ADDENDUM No. 5

REQUEST FOR QUOTATION No.: 1220-040-2021-061

TITLE: SOUTH SURREY INDIGENOUS CARVING CENTRE

ADDENDUM ISSUE DATE: DECEMBER 13, 2021

ASK-01

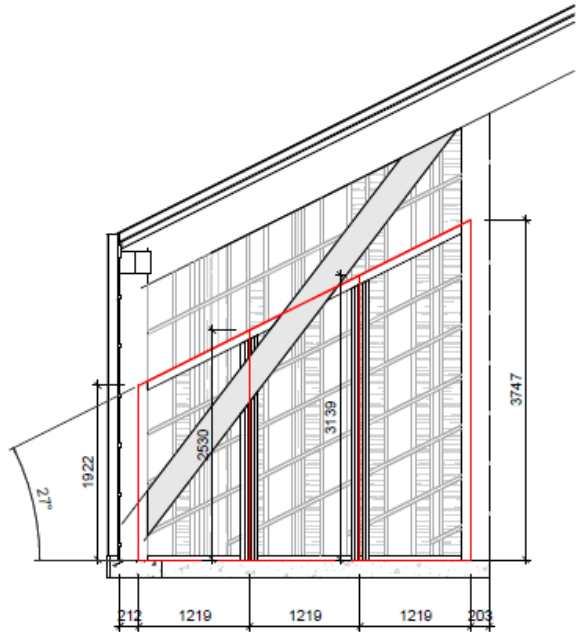
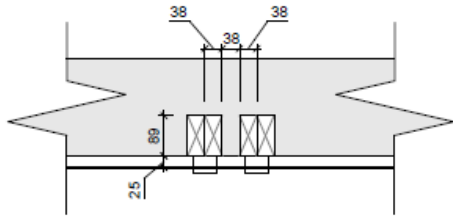
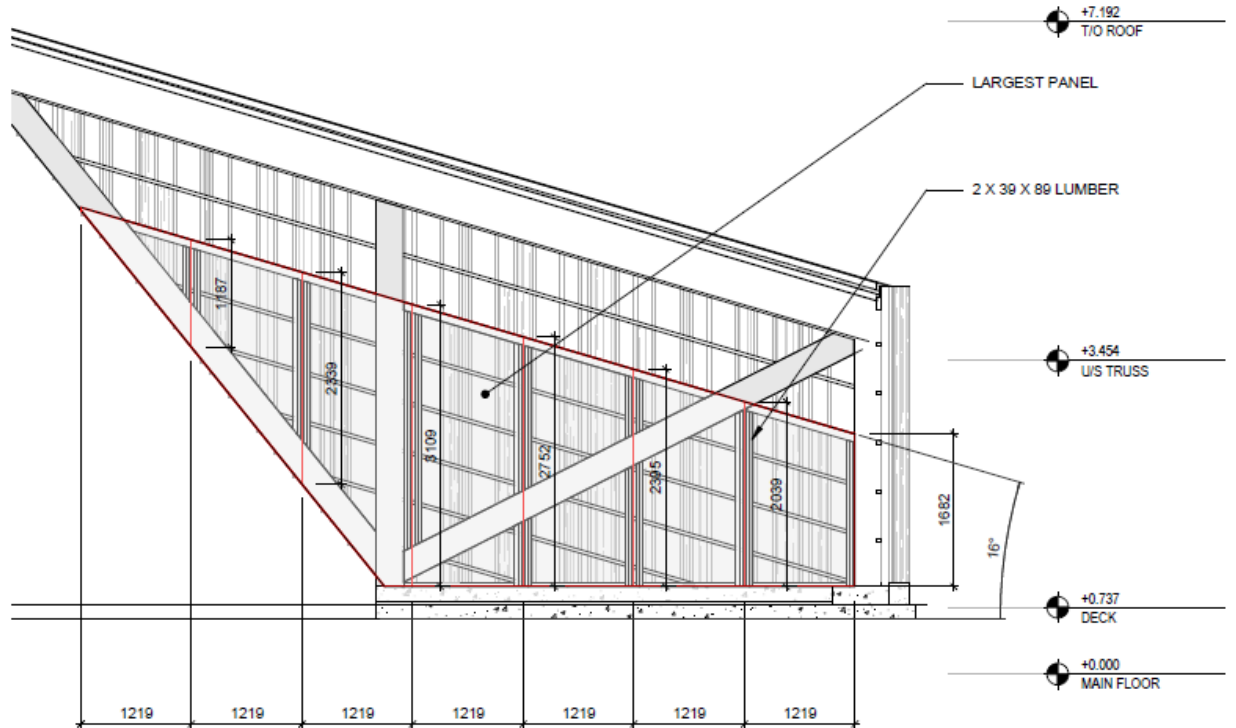
- A8. Metal is 16 ga. Refer to A29 in this Addendum.**
- Q9. The way the standoffs for the 16ga perforated metal screens on the east side of the building are drawn show 1" standoffs on the corners to the fir posts
This will not work for mounting. If you could let me know (via a detail) how these sheets are to be mounted that would be much appreciated

- A13.** This question is not clear. Please provide greater clarity.
- Q14.** Screens
1. These will have to be custom cut as the hole profile is not stocked anywhere.

2. These will have to be made in multiple pieces because of the size required. Will there be structure at 4' centres for the seems to land on?
 3. How many of the stand-offs are required (spacing)?

- A9. Please refer to Attachment 1 to this Addendum.**
- Q10. Just wondering if there has been clarification the P1 and P2 wall types, both used in the washroom, call for 5/8" GWB for P1 and 1/2" GWB for P2, is this the way they would like it installed? Or should I allow for both wall types to be 5/8" M2 Tech, this is the moisture board I prefer to use unless Dense Shield will be more appropriate, I did not see any materials specified.

- A14.** The perforated screen has been updated. New perforated sheets are to be round staggered - Ø.156" x .187" STAGGER - 304 stainless steel, 16 ga; Any size that is readily available and within 60% of open area specified would be considered acceptable. Allow for 10 bolts for each metal screen (number of bolts are based on the largest panel).

- For items 2 & 3, please refer to Attachment 1 to this Addendum.
- Q15.** Welded wire mesh
1. This is a custom holes size that will require 4 months to make. (2" x4" in mild steel is largest stocked mesh)

REFERENCE ATTACHED ELEVATED PERFORATED METAL SCREENS ASK-01
